AGENDA
Planning and Zoning Commission
May 21, 2025 – REGULAR MEETING

Meeting Date:	May 21, 2025	Meeting Title:	Planning Commission
Submitting Department:	Planning Department	Presenter:	Tyler Valentine
Agenda Item:	Three Development Plans for Lots 53, 57, & 58 within the Snow King Master Plan (P24-168, P24-174 & P24-175)	Public Comment:	Yes

Lot 57 – Summary of **New** Design Changes Since First Planning Commission Meeting

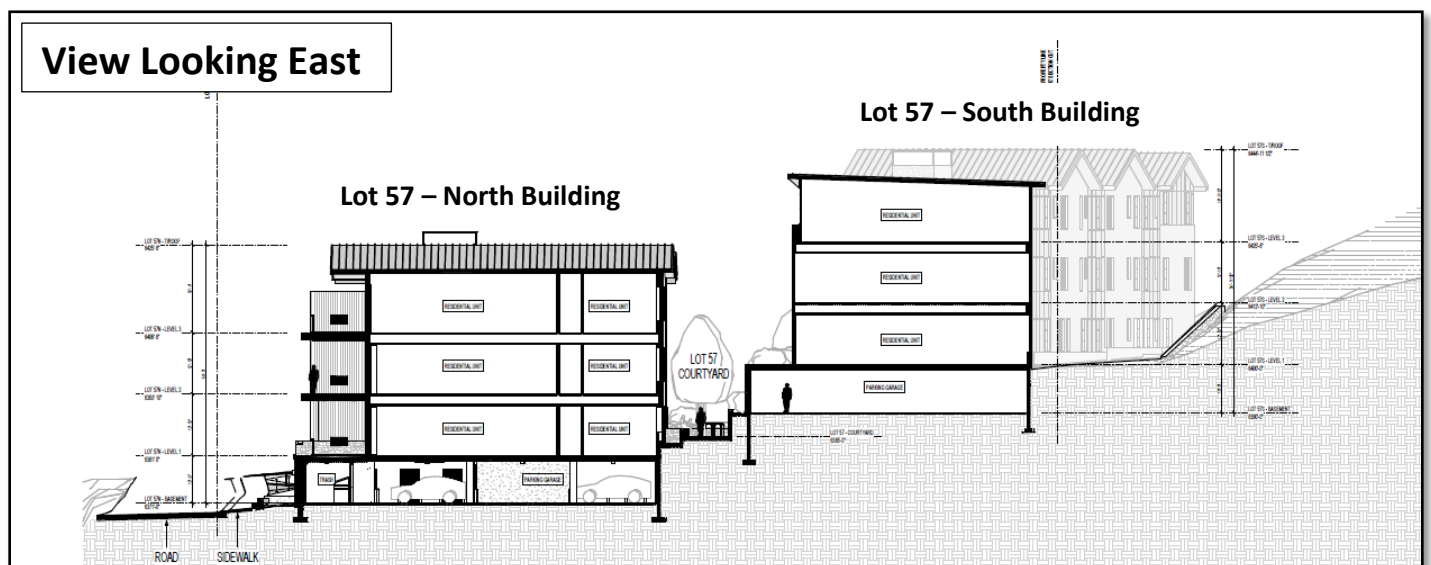
Amongst the three lots, Lot 57 deviates the most from the conceptual Master Site Plan, specifically because two buildings are proposed instead of one, and because the south building is pushed up against the southern property line and extends nearly to the eastern boundary, which is not explicitly prohibited but was not anticipated by the Master Plan. Although different from the conceptual Master Site Plan, this lot has no setbacks or limits on the number of buildings. The building shown for Lot 57 in the conceptual Master Site Plan illustrated one example of how a building could be situated, knowing it would need to step up the hillside and fit into the surrounding character. While stepping up the hillside can be accomplished in a single building design, multiple buildings can also accomplish the goal of stepping up the hillside, which is what the applicant has proposed. Page 86 of the applicant's submittal shows an east-looking section that demonstrates the stepping up the hillside with two buildings (visual provided below for reference). The proposed two-building plan also provides a visual break between the north and south buildings, allowing views and light to pass through the development from east to west.

Regarding the location of the south building on Lot 57, staff acknowledges that the Master Plan designated development rights on this lot with the understanding that future development would involve significant hillside disturbance due to the existing man-made steep slopes. And given that there were no assigned setbacks or limits on the number of buildings, buildings on Lot 57 can be located as proposed provided the design complies with all other applicable standards in the Master Plan (e.g., Design Guidelines, FAR, LSR, etc.) and is in character with the existing surrounding development. Staff do have character-related concerns over the northeast portion of the south building because it is located close to the road, which creates a canyon effect that is not in character with the surrounding developments. This topic is discussed further under the Dimensional Limitations Plan section. However, staff has added a condition of approval requiring the applicant to make design and site plan changes prior to Town Council review that are geared at reducing the bulk and scale and improving the character of this section of the south building. Overall, staff finds that as conditioned, Lot 57 is generally consistent with the proposed building envelope location described in this chapter of the Master Plan for Sub-Area 3.

Revised Lot 57 South elevation

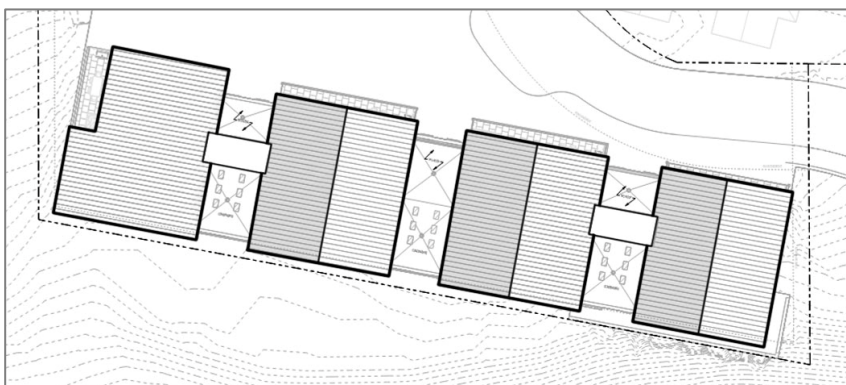
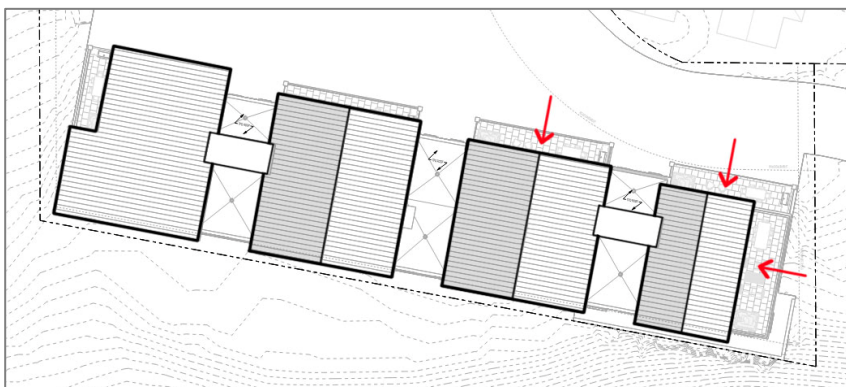
Change 1: Reduced the mass of the Lot 57 South building at the east end. The third floor eastern unit was changed from a 3-bedroom to a 2-bedroom and reduced in square footage. The eastern wall of this unit was pushed westward to create a larger stepback on the eastern façade. This also allowed us to entirely remove the north-facing balcony at that unit, which creates a large stepback at the north façade as well.

Lot 57 North – New Elevation

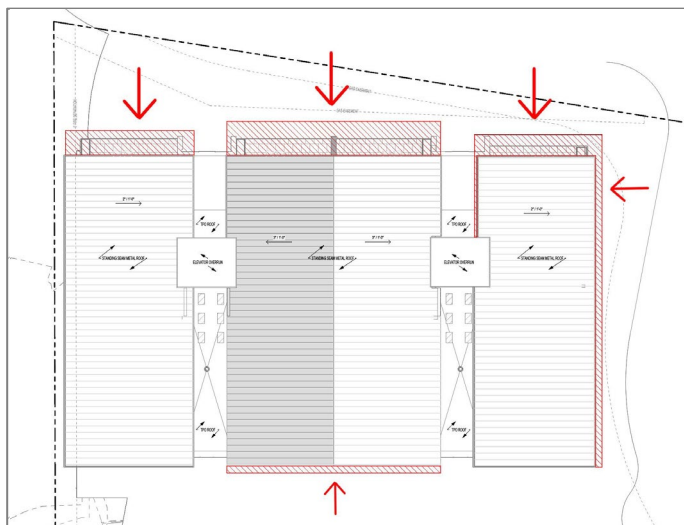
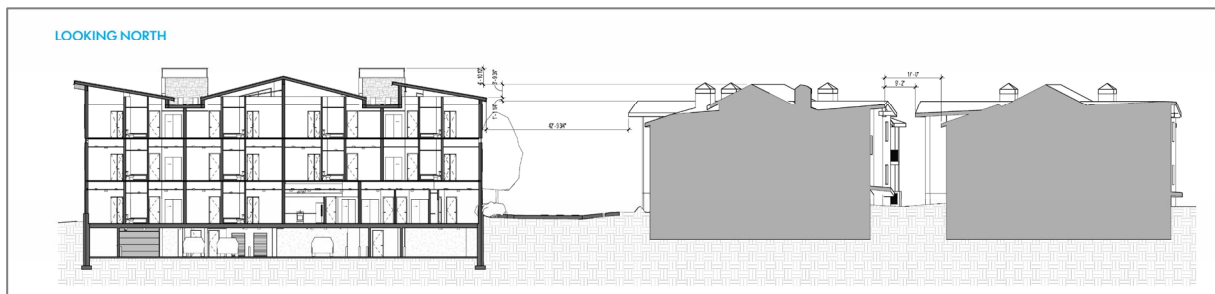
Change 2: North Building roof adjustments. The eastern shed roof was mirrored to slope in the opposite direction, resulting in a lower building height along the facade closest to Grand View. Additionally, all roofs were lowered by 1'-0" in height, and roof overhangs were pulled back to only extend 3'-0" from the exterior wall.

Lot 57 South – New Elevation

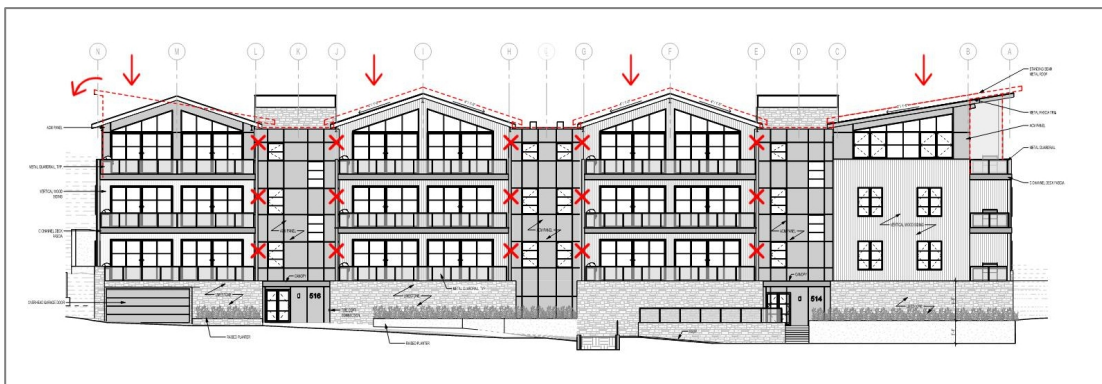
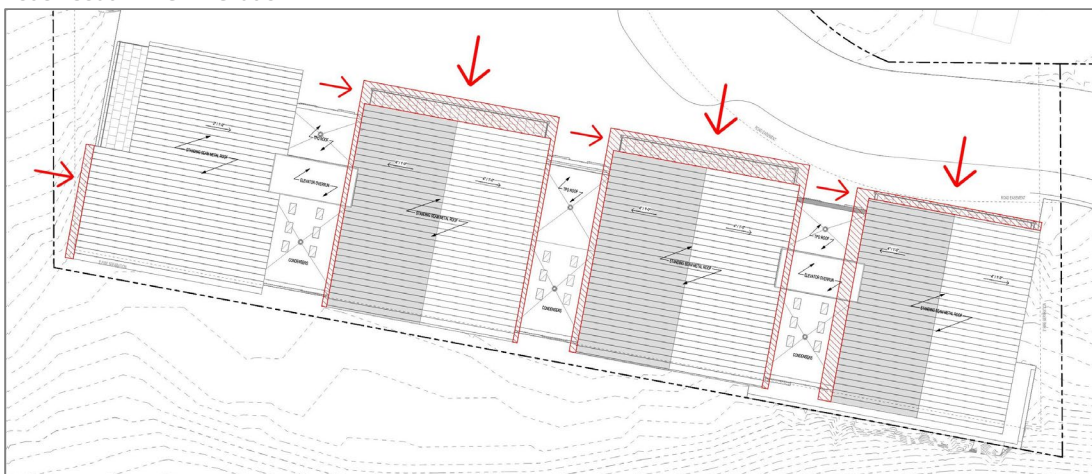
Change 3: South Building roof adjustments. The easternmost roof was changed to a gable roof, which greatly reduces the height of the building at the east façade. Additionally, all roofs were lowered by 1'-0" in height, and roof overhangs were pulled back to only extend 3'-0" from the exterior wall.

Lot 53 – New Elevation

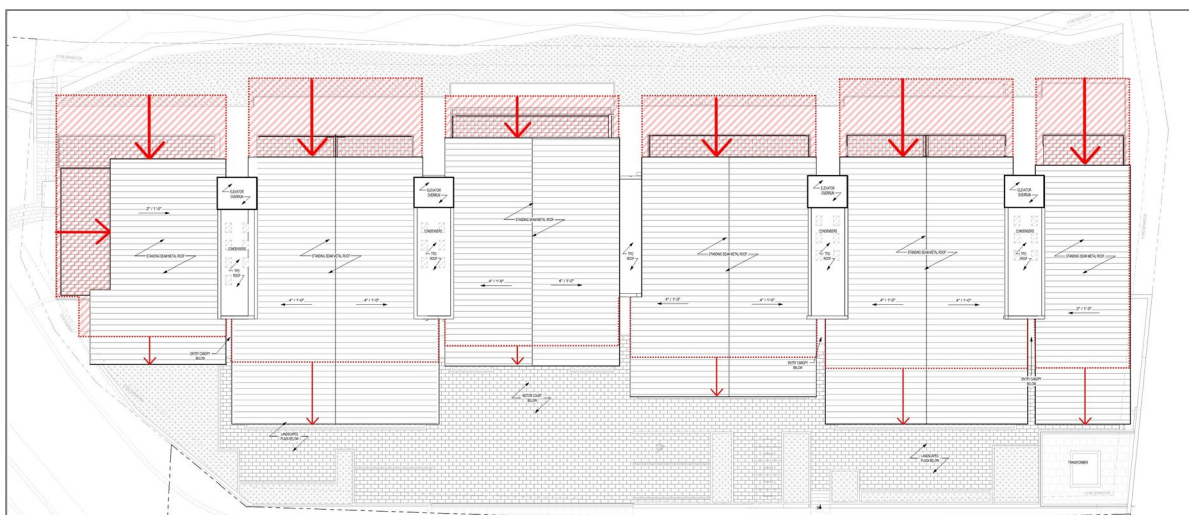
Change 6: Roof adjustments. In addition to pulling the building south, the third floor roofs were also reduced in size and in height. All the gable roofs were lowered by 1'-0" in height, and the shed roofs on the east and west end were lowered by 2'-0". Additionally, roof overhangs were pulled back to only extend 3'-0" from the exterior walls.
